# Mixed-mode return loss limits

P802.3ck D3.0 comment 185

Piers Dawe, Nvidia

# Comment 185 for C2M

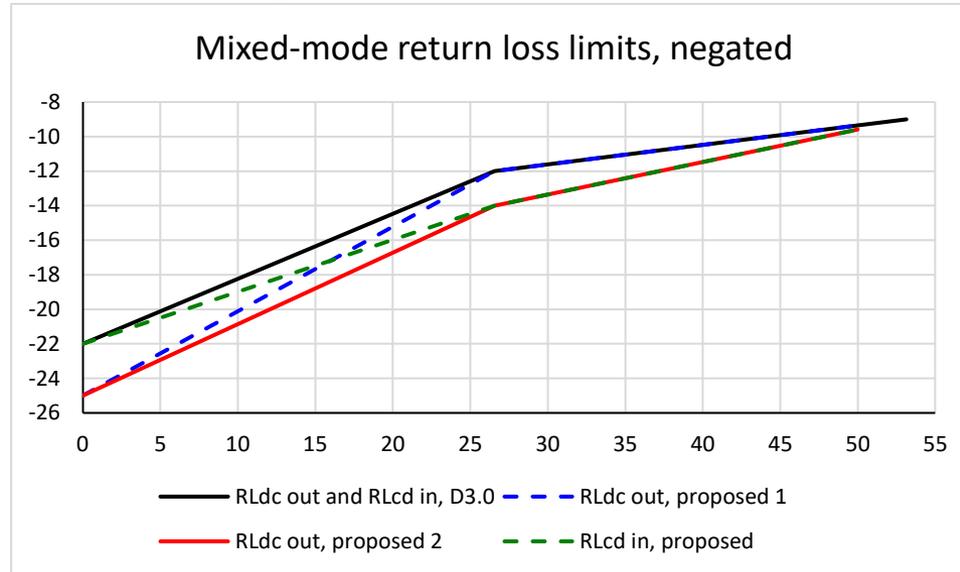
- Specs should be tightened

- This is what the comment proposes:
  - In Equation 120G-1, change 22 -20f/fb to 25 -26f/fb
  - If correcting for increased compliance board loss,
  - change Equation 120G-1 from 22 -20f/fb, 15 -6f/fb to 25 -22f/fb, 19 -10f/fb,
  - change Equation 120G-2 from 22 -20f/fb, 15 -6f/fb to 22 -16f/fb, 19 -10f/fb

Figure 162-8—Cable assembly differential-mode to common-mode return loss

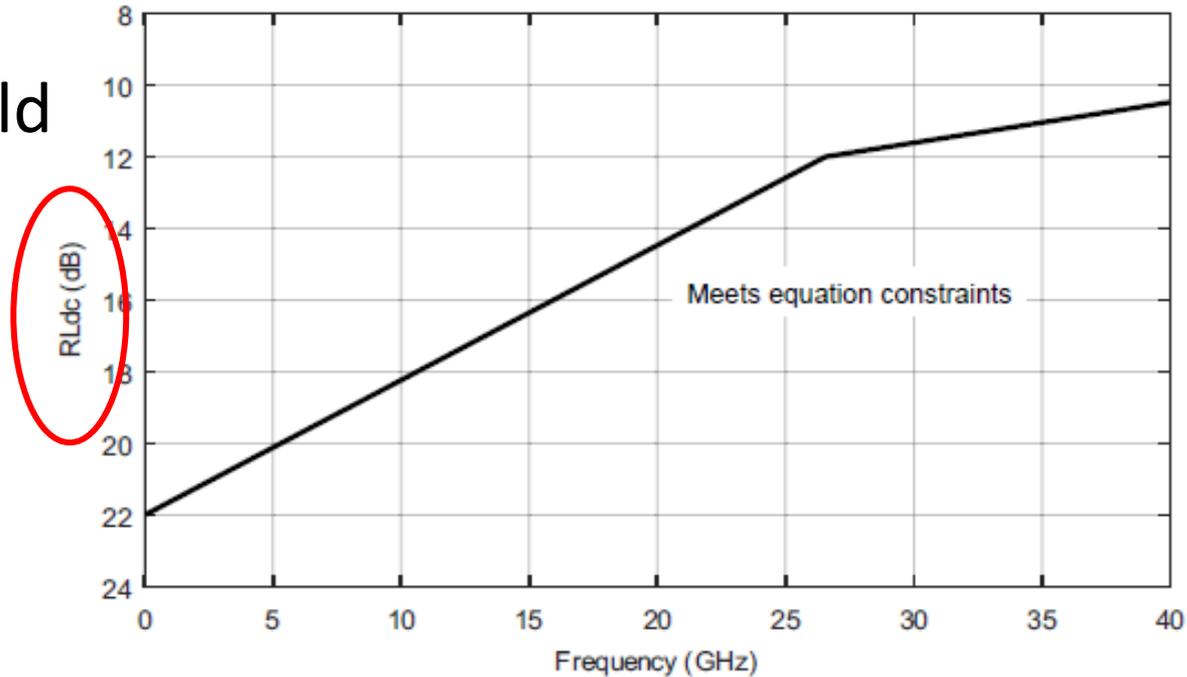
- This should be RLcd
